Project	IEEE 802.16 Broadband Wireless Access Working Group < http://ieee802.org/16 >	
Title	Editorial instructions pertaining to comments submitted in P802.16c/D3 ballot	
Date Submitted	2002-09-11	
Source(s)	Carl Eklund Nokia P.O. Box 407 FIN-00045 Nokia Group	Voice: +358718036566 Fax: +358718036851 mailto:carl.eklund@nokia.com
Re:	P802.16c/D3 Sponsor Ballot	
Abstract	This document contains the suggested editorial instructions.	
Purpose	Comment resolution	
Notice	This document has been prepared to assist IEEE 802.16. It is offered as a basis for discussion and is not binding on the contributing individual(s) or organization(s). The material in this document is subject to change in form and content after further study. The contributor(s) reserve(s) the right to add, amend or withdraw material contained herein.	
Release	The contributor grants a free, irrevocable license to the IEEE to incorporate material contained in this contribution, and any modifications thereof, in the creation of an IEEE Standards publication; to copyright in the IEEE's name any IEEE Standards publication even though it may include portions of this contribution; and at the IEEE's sole discretion to permit othe

Figure 50a—Initial Ranging – SS (part 1)

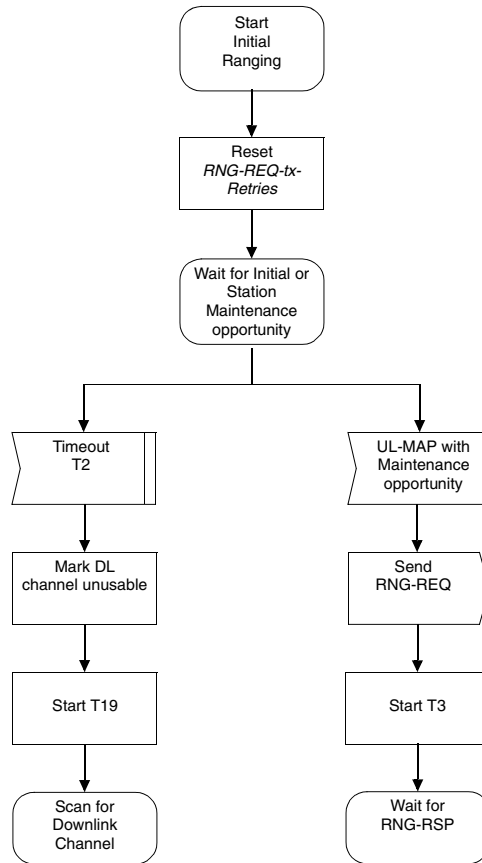
Replace figures 50a and 50b with figures below

Figure 46—Obtaining downlink synchronization

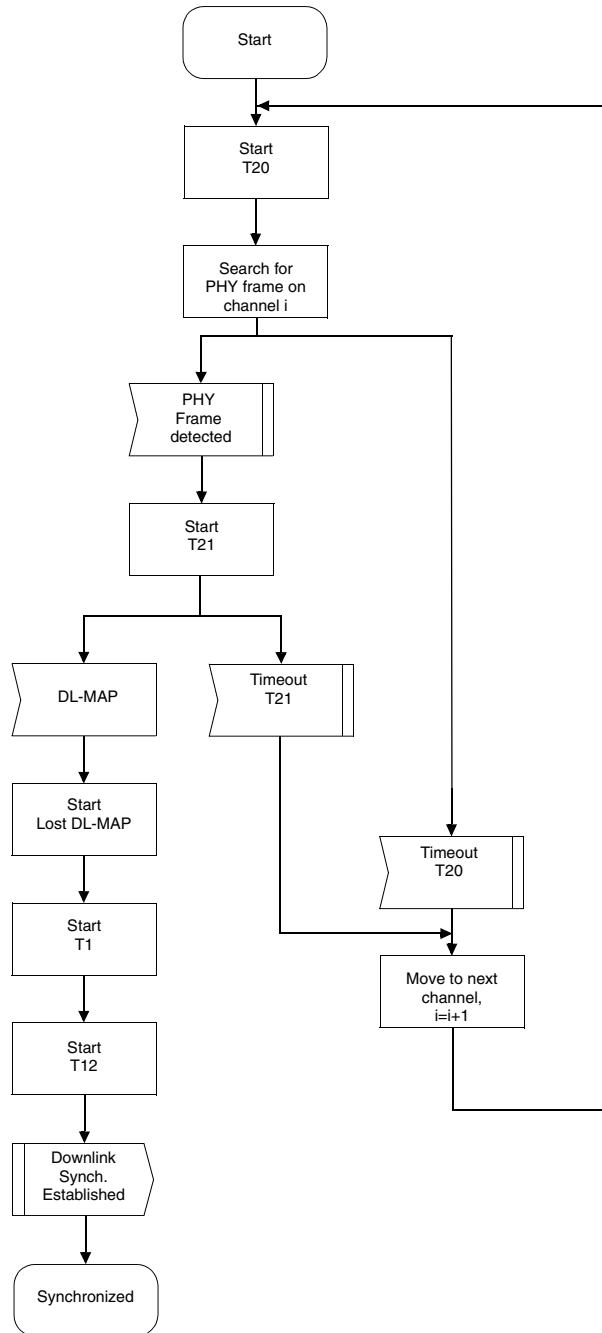
Replace figure 46 with the figure below.
